**ARINC SPECIFICATION 858 PART 3  
TABLE OF CONTENTS**

#### 1.1 Purpose

This document serves as an ARINC standard to define a Common IPS Radio Interface (CIRI) protocol for conveying radio status information and for transferring digital data between the Airborne IPS System and Airborne Radios. This standard includes the functional description of the protocol including applicable use cases, protocol message formats, and protocol operation for both control plane and data plane exchanges. The protocol is intended to operate over a variety of on-aircraft communication means including, but not limited to, ethernet-based and ARINC 664-based aircraft networks.

Figure 2-2 – Notional CIRI Protocol Context

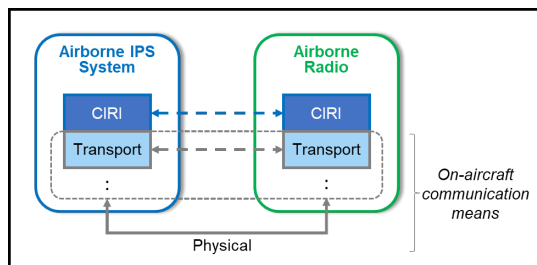
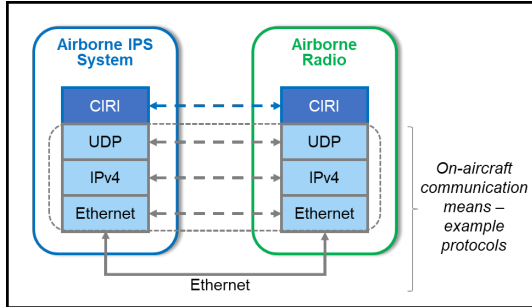
Commented [SM9]: [P3-M22-01 – M.Skorepa/Z.Jaron-HON]: Clarify the diagram to indicate that it is an example, or abstract the diagram.

Commented [OML10R9]: M23 – Fig 2-2 is abstracted; Fig 2-3 is example.

Figure 2-4 – Basic Control Plane Communication Pattern

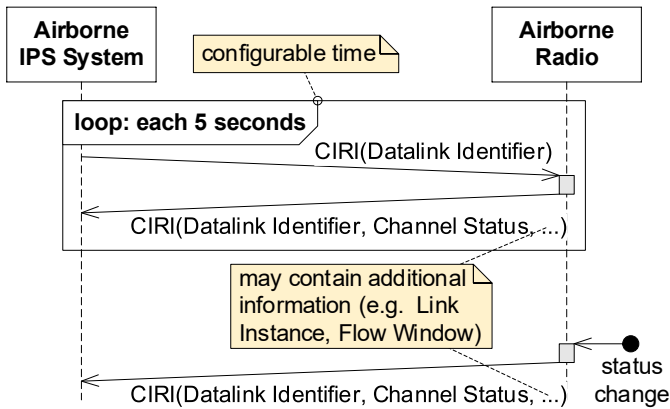
**Commented [FW11]:** Added this to show the purpose of the periodic control plane message. Please remove if you consider that this is unnecessary.

Question: Is the status query limited to a single link\_id, or many link\_ids can be queried in a single message. Assumption: it’s the second case (because why not?).

Figure 2-6 – Flow Control Example Sequence

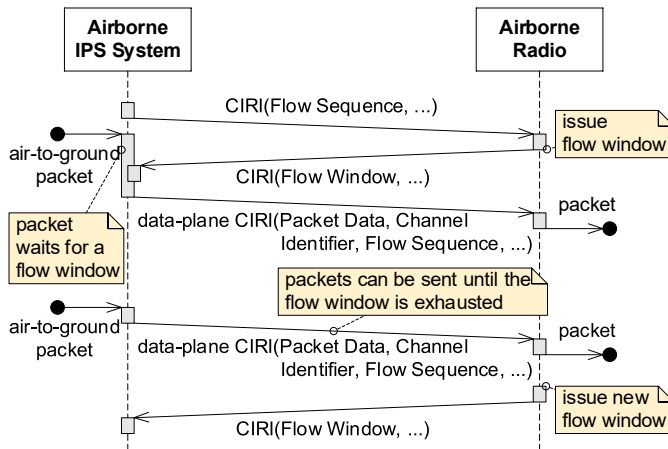
**Commented [FW21R19]:** The question stands: Can IPS Airborne system send data packet to radio before Flow Window message is received? If this is forbidden by this protocol, then the link initialization on the layer 3 will be delayed until the CIRI flow window is received.

**Commented [JZ22R19]:** The Airborne IPS System needs to wait for the first control-plane CIRI message, that will either establish the flow window (if the corresponding Flow Window option is present), or it will disable flow control for the datalink channel (if the corresponding Flow Window option is absent).

Figure 4-1 – Airborne IPS System Endpoint Control Plane Operation

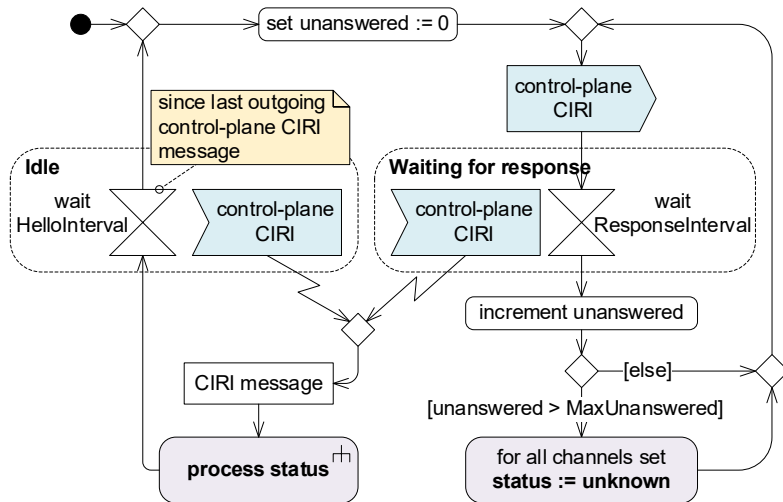
Also, the flow control paragraphs may be moved below the Figure 4-1.
